**FINAL  
ENVIRONMENTAL IMPACT REPORT  
FOR CHULA VISTA MALL EXPANSION  
EIR-91-04  
SCH Number 91051042**

**RECON NUMBER 2333E  
DECEMBER 10, 1991**

RESPONSES

FIGURE 6. SOUTHERN ELEVATION

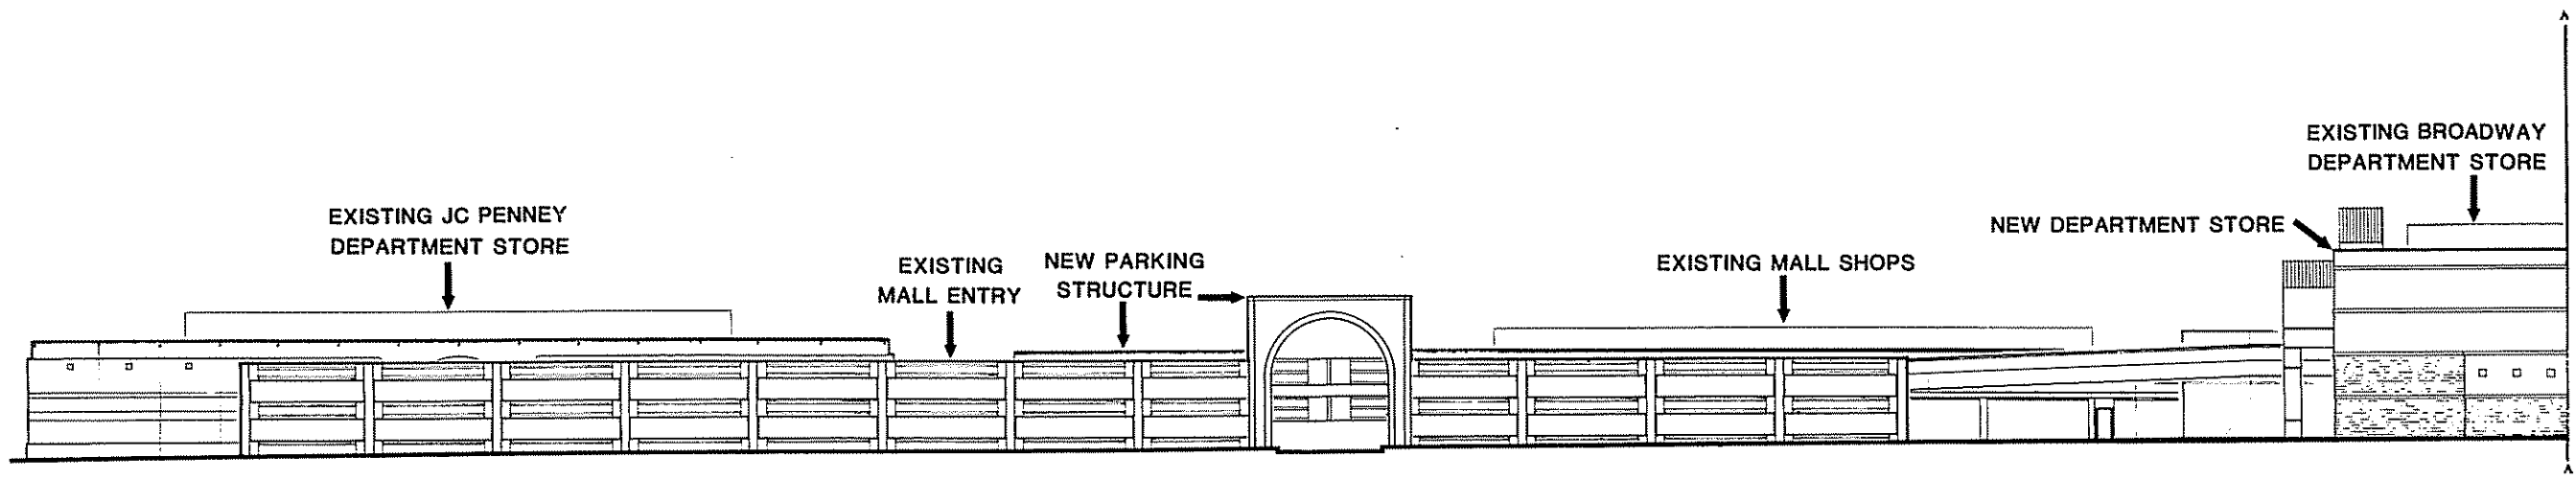
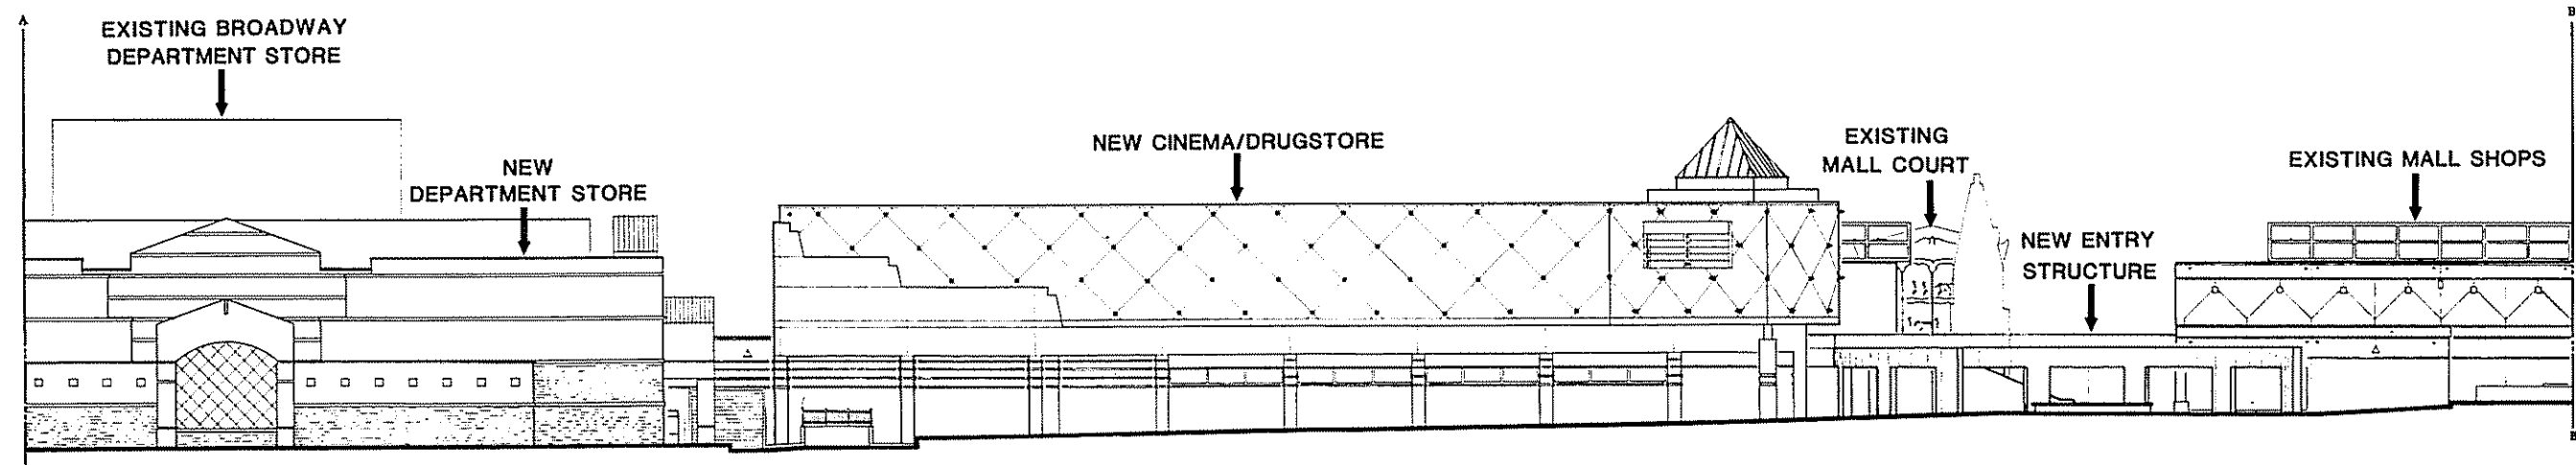
- 4 1. Steps should be taken to blend the Broadway Department Store building more harmoniously into the design of the project.
- 5 2. A more specific description of the impact to traffic on "I" Street should be included.
- 6 3. More information should be provided regarding the impact on the existing theaters by the development of a multi-plex theater. Specifically what would be the effect on downtown businesses if less people came downtown to go to the theater as a result of the development of the 10-plex at Chula Vista Mall.
- 7 4. Clarify discrepancies between the Scripps Hospital Expansion Project EIR Traffic Section and the Chula Vista Mall Expansion Project Draft EIR.

4. This comment is noted. However, the Broadway department store is not within the proposed expansion area of the mall. Any modification of the Broadway department store to blend with the previous and proposed mall expansion projects would require additional discretionary review by the City of Chula Vista.
